Automotive Sales and Detail Center PDP and SUP

Application #PL2020-044 and -045

June 9, 2020

1 Preliminary Site Plan
Scale 1" = 30'-0"

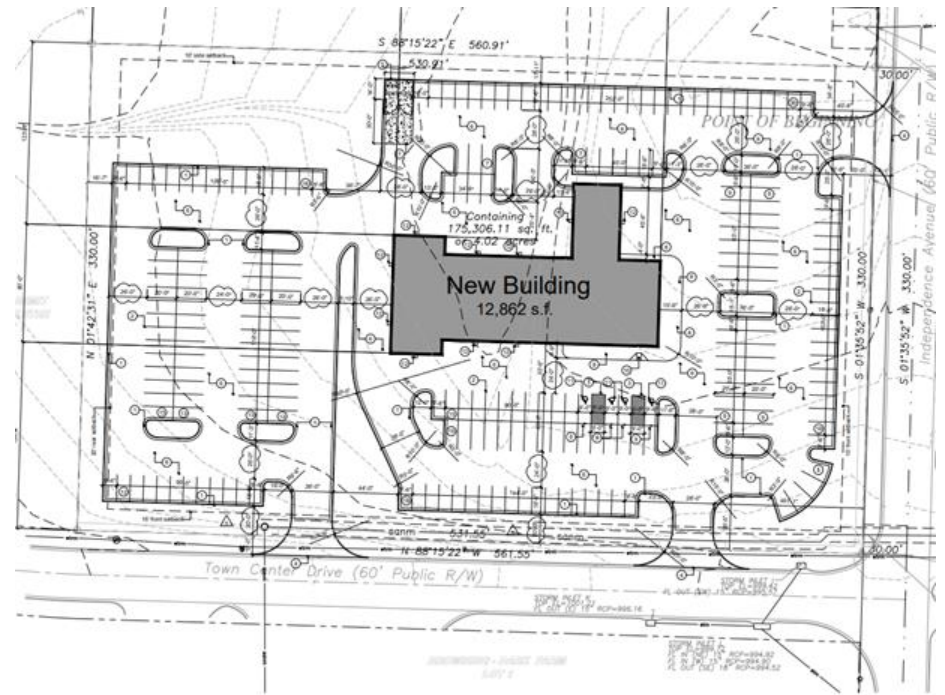
- Required - 20' from north (rear) property line
- Proposed - 17'-11" from north (rear) property line
- Recommended – Staff supports a modification to allow a 17'-11" setback from the north (rear) property line.

1. A modification shall be granted to the 20' vehicle display area setback requirement, to allow a 17'-11" setback from the north property line.
2. Submittal of a geotechnical report to the City for the reclaimed pond site shall be required prior to the issuance of any building permit.

Yours Truly
Elevations

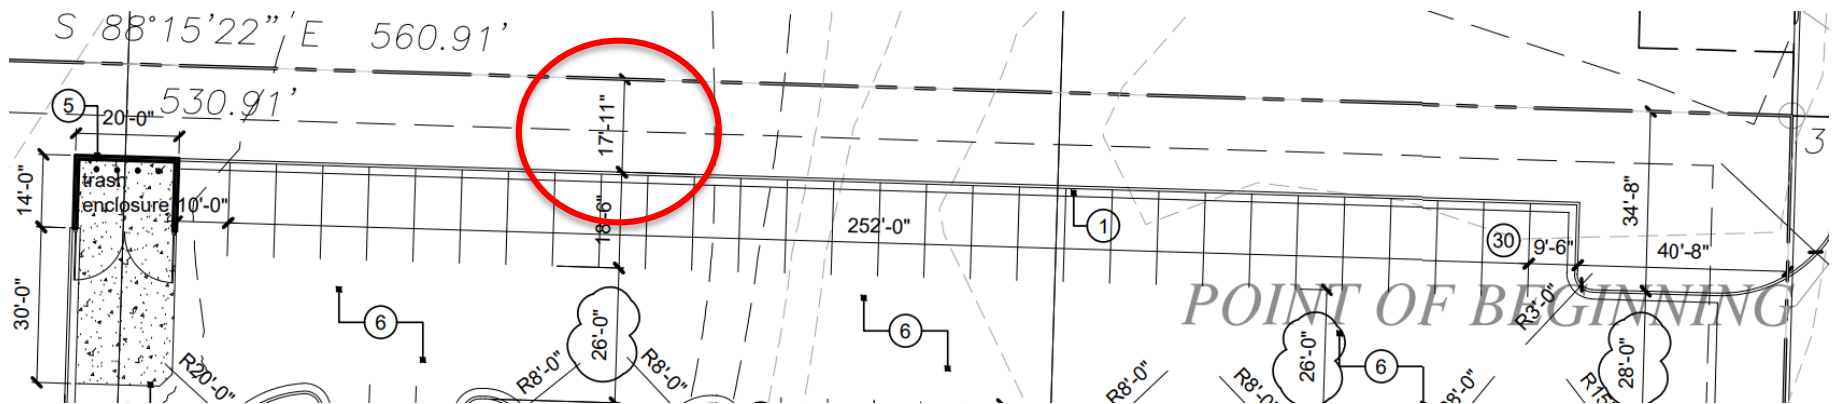
3. The special use permit shall be granted for a period of 30 years.
4. The prefinished, corrugated, architectural horizontal rib metal panel shall be an allowed accent material on the south, north and east facades as shown on the building elevations dated March 24, 2020. ***(added by City staff)***

5. The non-insulated stucco-finished metal wall panels shown on the building elevations dated March 24, 2020, shall not be allowed on the proposed building . Said metal wall panels shall be replaced with an approved material for commercial/retail buildings listed under UDO Section 8.170.A. ***(added by City staff)***
